# **AGENDA FOR THE CANTERBURY BANKSTOWN LOCAL PLANNING PANEL MEETING**

**1 DA-305/2022 - 41 Burbank Avenue, East Hills**

<b>ITEM 1</b>	<b>DA-305/2022 - 41 Burbank Avenue, East Hills</b>
	<b>Demolition of existing dwelling and construction of a two-storey attached dual occupancy with shared semi basement garage and shared spa/pool with strata title subdivision into two lots. Waterfront boatshed, ramp and gazebo to be retained.</b>
<b>FILE</b>	<b>DA-305/2022 – Bunya / Revesby Ward</b>
<b>ZONING</b>	<b>R2 Low Density Residential</b>
<b>DATE OF LODGEMENT</b>	<b>26 April 2022</b>
<b>APPLICANT</b>	<b>Amin Azam</b>
<b>OWNERS</b>	<b>Nina Trad Azam</b>
<b>ESTIMATED VALUE</b>	<b>\$1,796,342</b>
<b>AUTHOR</b>	<b>Planning</b>

## **DA-305/2022 ASSESSMENT REPORT**

Figure 5: RL Source: Architectural Plans Revision E

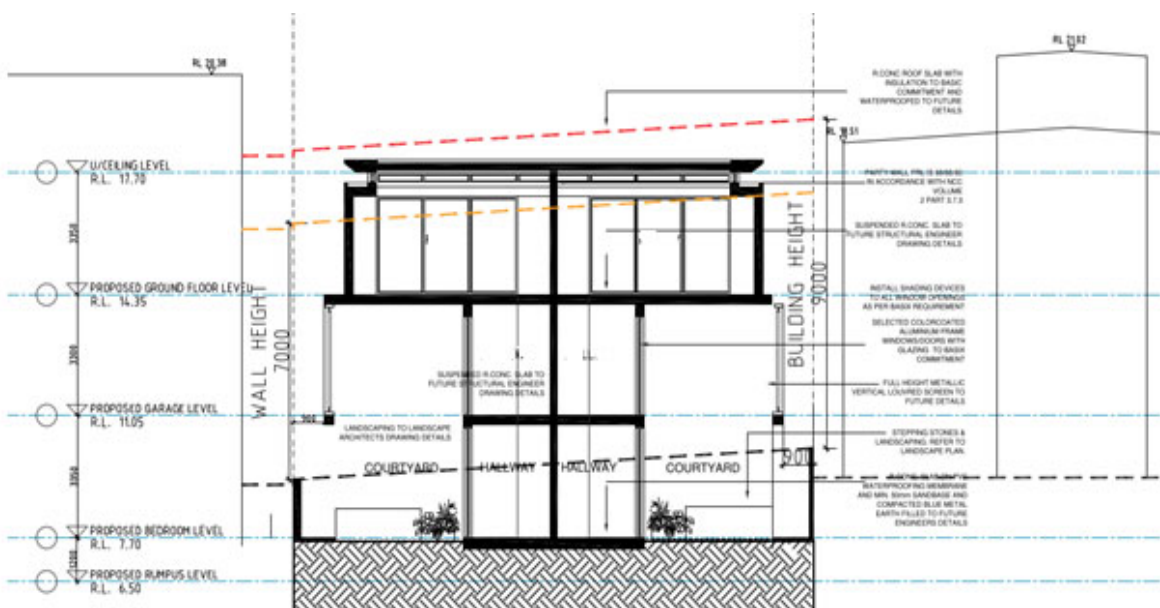
As seen in the figure above, the proposed building height non-compliance is at 17.40 RL, and comparatively lower than the building height of 20.38 RL for 39 Burbank Avenue and 18.51 RL for 51 Burbank Avenue. It is demonstrated that while the approved building height variation were supported for the immediate adjoining properties, the applicant has designed the building height lower despite the non-compliance with the development standard.

**Figure 6:** Three Storey Element (Section) **Source:** Architectural Plans Revision E

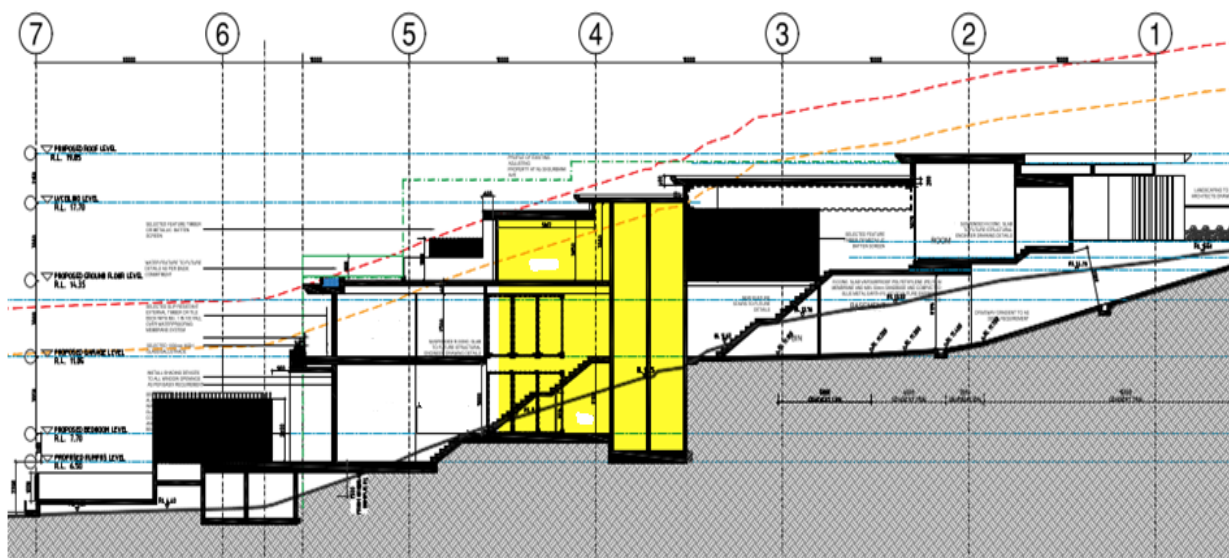
As seen in the figure above, the proposed three-storey element consists of the lower floor staircase, elevator and hallway access; the mid floor staircase, elevator, hallway access, bedroom 1 and bathrooms; and the upper floor staircase, elevator, hallway access, laundry and pantry, kitchen and dining elevator, and family room. The three-storey element of the proposal represents approximately 9.4% of the building footprint. In this regard, the proposed development is inconsistent with objective (b) of Clause 4.3(2) of the BLEP 2015.

Figure 7: Wall Height non-compliance

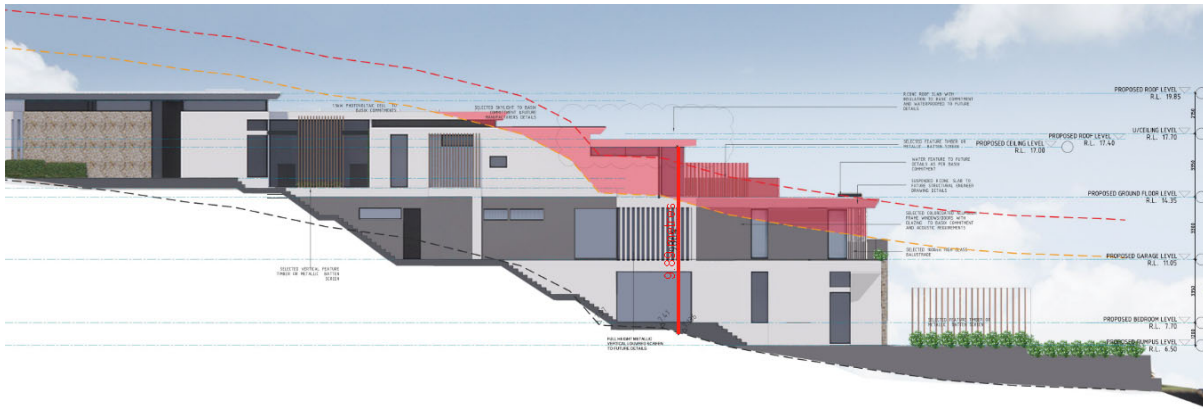
The maximum wall height of the proposed development is measured at 9.864m along the northern elevation (from 17.00 RL to 7.136 NGL). The non-compliance represents a 40.9% variation to the development standard.
